AFFCO IMLAY

**ANNUAL AIR
DISCHARGE
MONITORING REPORT –
2020 / 2021**

AIR DISCHARGE PERMIT:-
ATH-2007010926.01

Imlay Rendering Plant Biofilter Systems Inspection

101: Fan 14.1 outlet transition duct seal leak

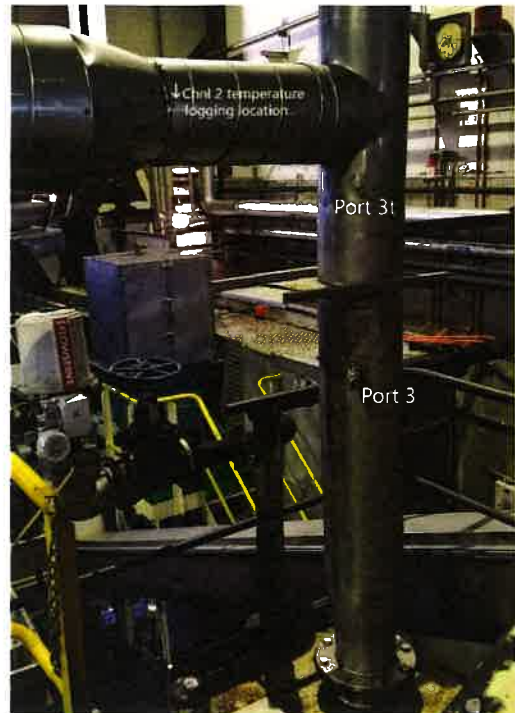
- b) Distinct wet-area odour was sensed along the north side of the processing building in the vicinity of the covered biofilter. This was traced to a significant leak at the outlet seal of the uncovered biofilter fan 14.1. This odour could no longer be sensed at 40 to 50m downwind from the fan. (Although the wind was from the south-east, downwind from the fan was more to the west due to air flow along the north side of the rendering plant building).

No	Item	Issue	Comment
2021-1	Fan 14.1 Discharge Duct Sealing	Previous perished seal was replaced but bolts securing bottom seal clamping bar have worked loose from fan vibration resulting in a segment shaped opening between duct and seal - see photo 101.	Not an easy permanent fix due to inevitable vibration from fan and need for more secure bolting. Temporary beams top and bottom with ties each side might reduce gap but better internal design for clamping (with the inevitable extended shutdown needed) makes this a likely winter maintenance task.
2021-2	Fan 14.1 Discharge Duct Sealing	In replacement of the former perished seal two new holes appear to have been drilled and tapped for new bolts. The old bolt holes remain open with a steady stream of air coming from each. See photo 102. Any leaks in piping between the fan and biofilter need to be sealed if readily possible. Leaks though small have a cumulative effect in what odour can be sensed and the fewer the better.	Seal any old unused bolt holes.

107: Port 5 - Blood Centrifuge

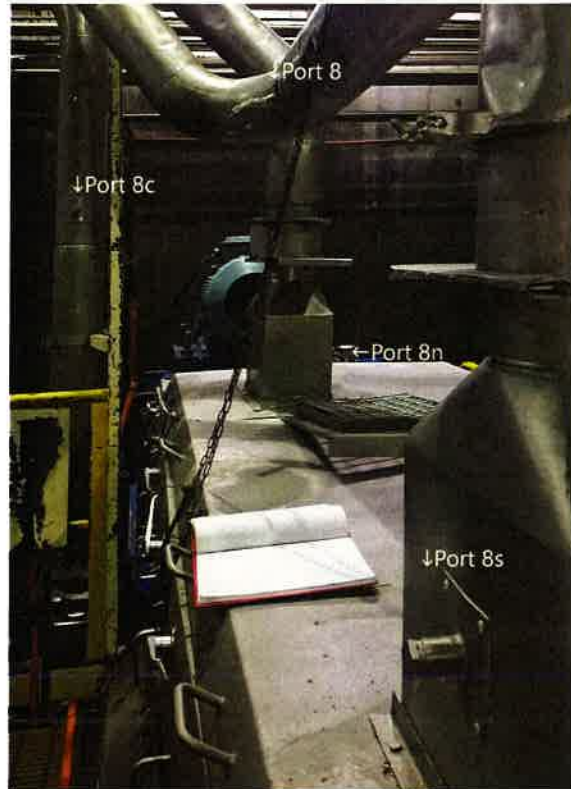
- g) **Blood Decanter (Port 5):** See photo 107. As reported in 2019 and 2020 significant steamy discharge occurs from the conveyor under the blood decanter. It appears there is inadequate head space in the conveyor under the decanter to allow air at the conveyor discharge points to be drawn in and along to the 150 mm diameter extraction duct leg. The added leg of 76mm dairy tube was plainly an attempt to capture vapour from the conveyor east exit but is too small for the vapour flow. It is recognised that the decanted blood conveyor may not be able to be modified due to the nature of the blood and that the previously mentioned raiseable hood for extraction would not be simple given the need to frequently move bins in and out. There are various options around the issue. It is assumed they are being considered. In the meantime, fortunately, there does not seem to be any significant adverse odour associated with the steam emission.
